**TOWN OF NEWBURGH
PLANNING BOARD
TECHNICAL REVIEW COMMENTS**

PROJECT: A. DUIE PYLE MAINTENANCE BUILDING
PROJECT NO.: 19-09
PROJECT LOCATION: SECTION 95, BLOCK 1, LOT 69.1 & 79
REVIEW DATE: 10 MAY 2019
MEETING DATE: 16 MAY 2019
PROJECT REPRESENTATIVE: LANGDON ENGINEERS/Justin Macalintal, Snr. Staff Engineer

**Re: A.Duie Pyle Maintenance Building
Responses to Technical Review Comments
Project No.:PB 2019-09
Langan Project No.: 190048601**

Drawing Title: **SITE PLAN**

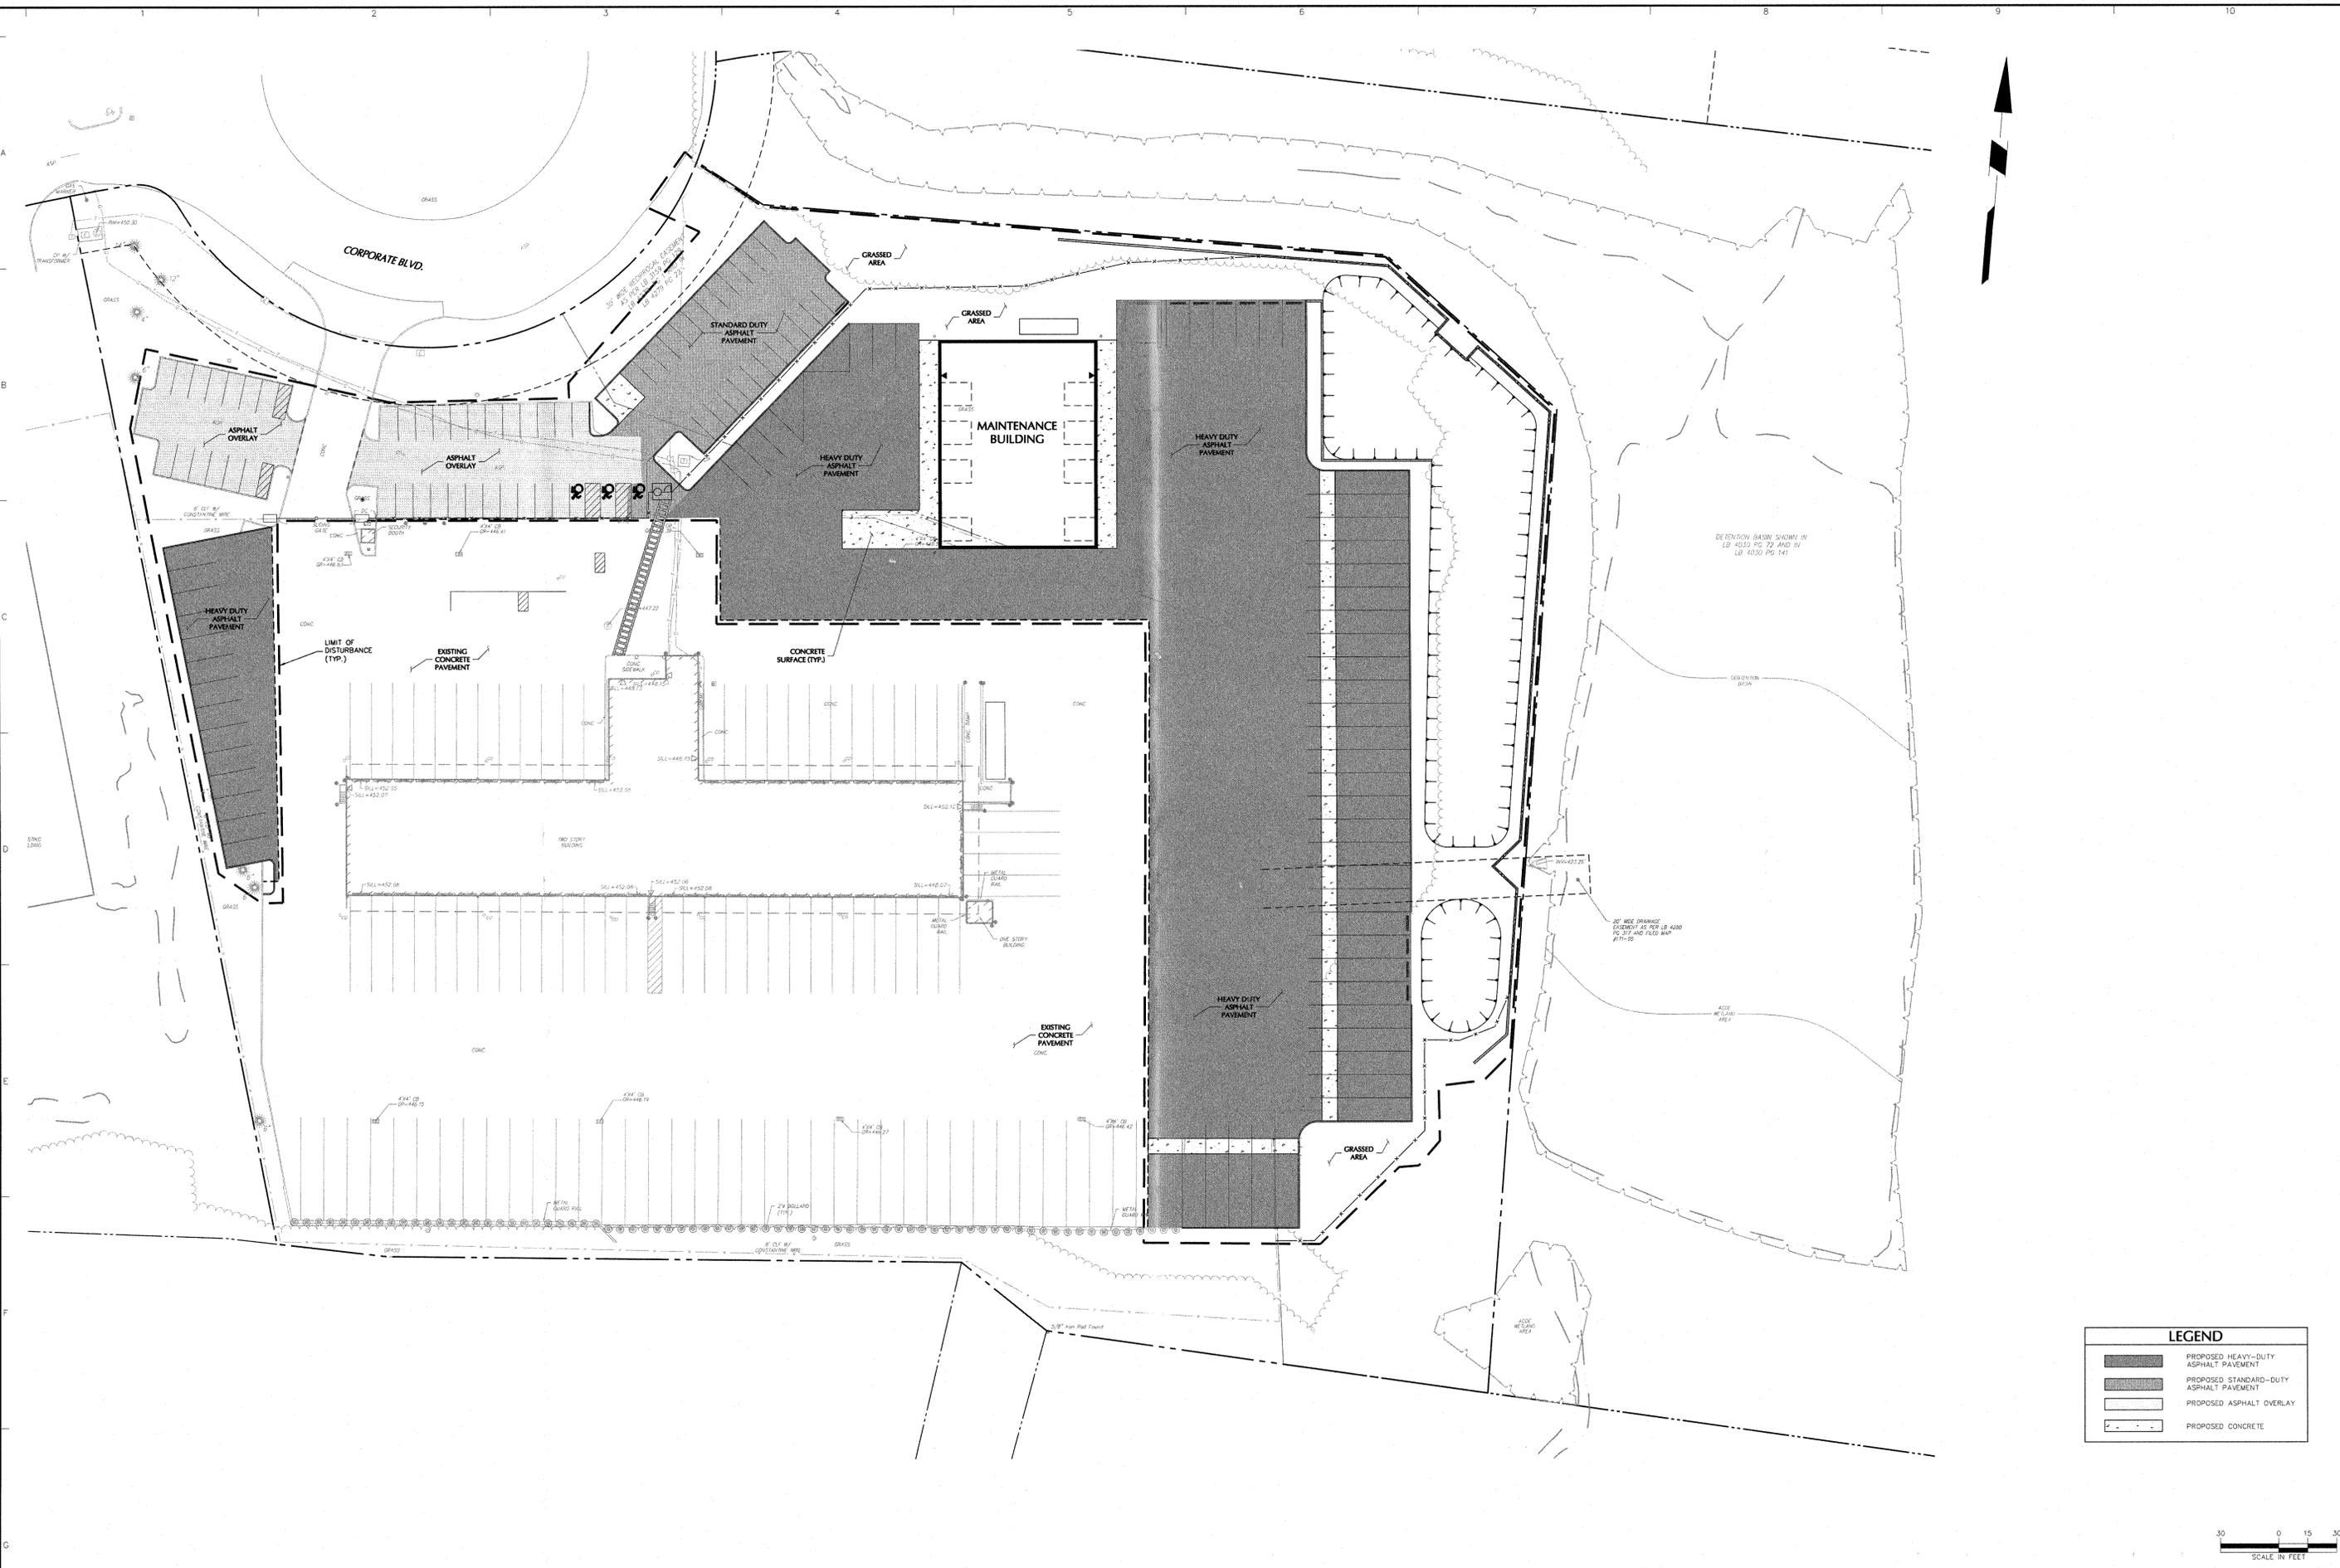
Comment 1. The existing employee parking lot surface is rough. The plan shows that the existing 23-space lot will be resurfaced, stopping short of the concrete driveway. We recommend that the resurface extend all the way to the concrete driveway, an additional ±260 SF. In addition, the 13-space employee parking lot could use a resurfacing, or at a minimum, the parking stalls restriped to Town standards.

Comment 2. The site plan should show new striping for the two existing employee parking lots.

Comment 7. Accessible parking spaces are depicted on the opposite side of the fence. Applicants are requested to evaluate the accessible route as a row of parking exists on the interior side of the fence. A gate is identified in this vicinity as well.

Response: The Applicant agrees to mill and overlay the employee parking area in the front of the property. See sheet 4 of 12 of the revised site plans.

Response: The plans were revised to show the two existing employee parking lots to be restriped. See sheet 4 of 12 of the revised site plans.

Response: The site plans were revised to remove employee parking spaces inside the fenced area in order to keep employee traffic and truck traffic separate for safety purposes. The proposed handicap spaces are located next to the proposed turnstile entrance to the facility. See sheet 4 of 12 of the revised site plans.

Drawing Title
UTILITY PLAN

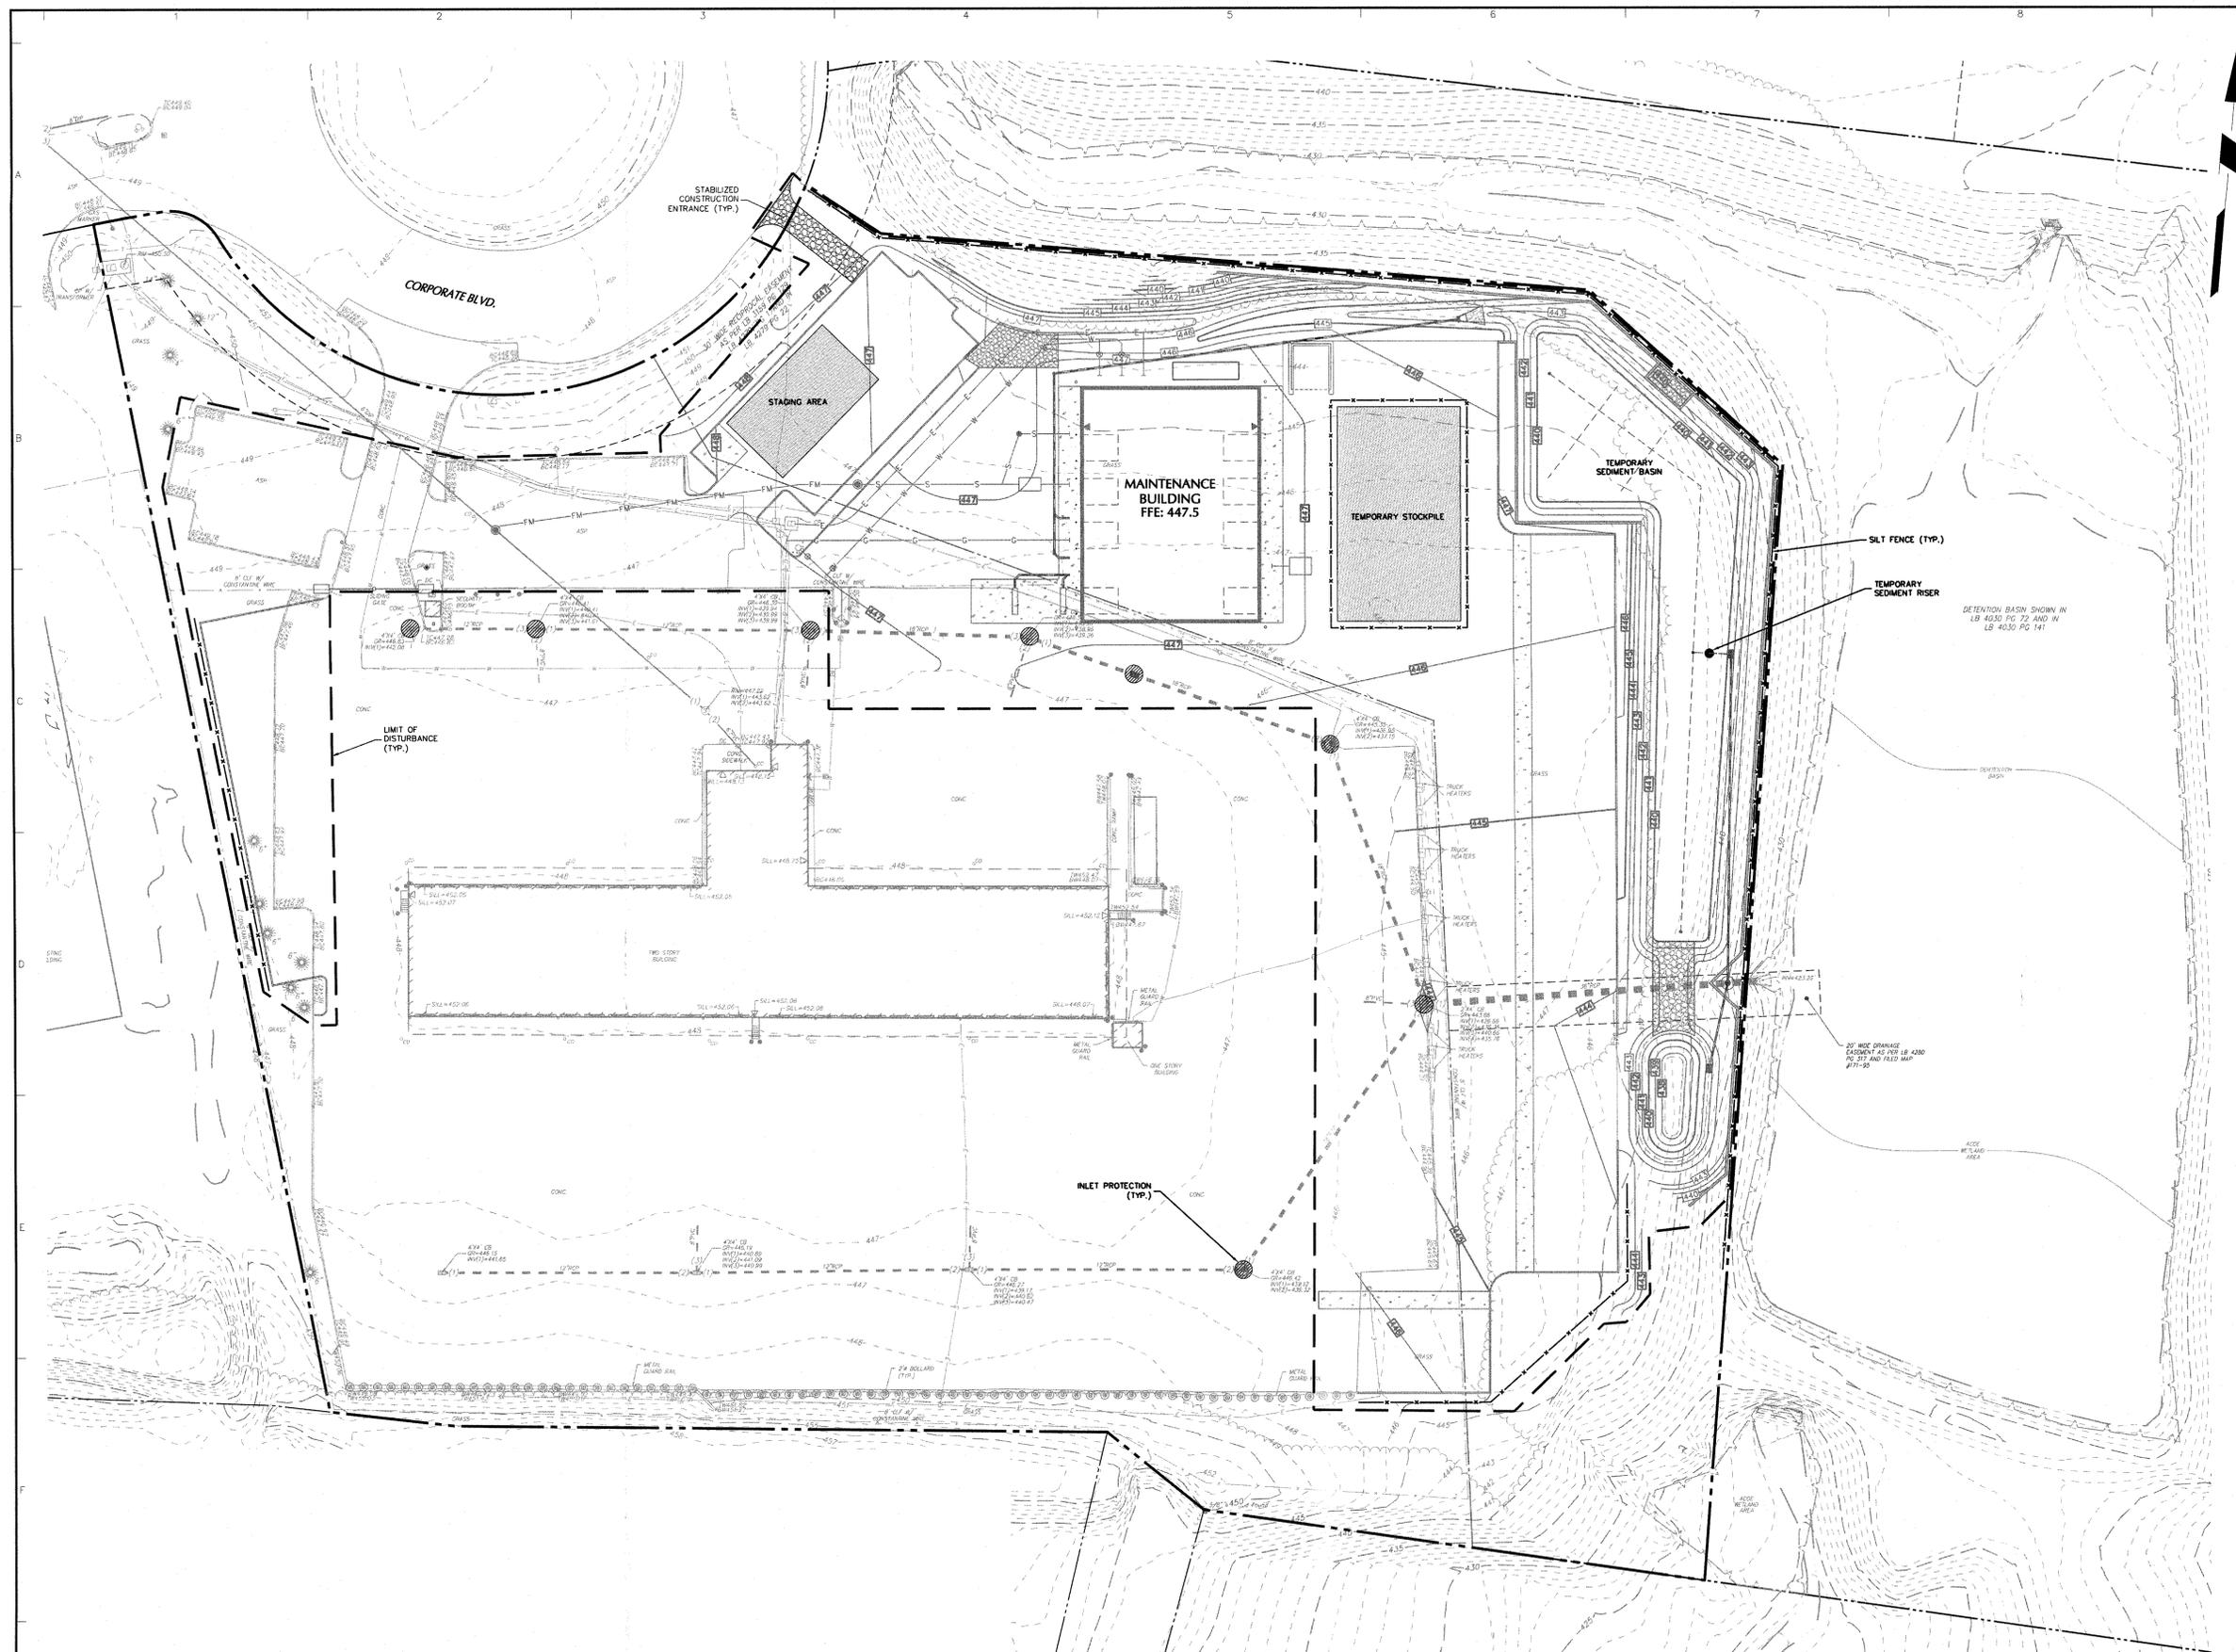
Comment 2. Water connection to the building must be designed to separate the fire flow and potable water systems whereby if fire flow systems are terminated potable water to the building is terminated. Typical detail for Town of Newburgh is required.

Response: The utility plan was revised to show separate fire flow and potable water service lines to the proposed maintenance building. Water utility details for the Town of Newburgh were added to the detail sheets.

TYPICAL SEGMENTAL BLOCK RETAINING WALL

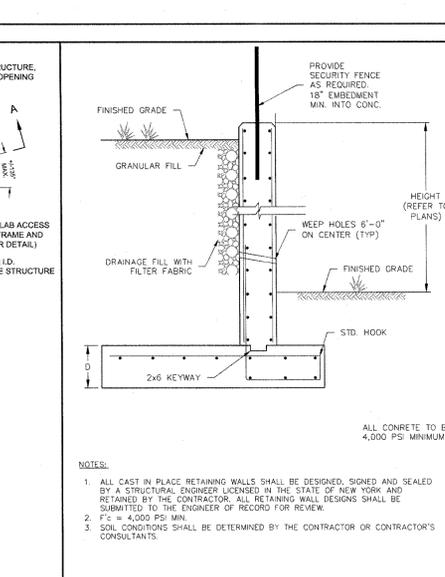
Comment 11. Extensive retaining walls are proposed along the eastern portion of the site. Design of these retaining walls should be incorporated into the plan sheets. An evaluation as to the impacts of the retaining wall on Stormwater Management Facilities located in close proximity should be prepared.

Response: The site plan was revised to include a segmental block wall detail. The structural design of the retaining wall will be included with our application for building permit.
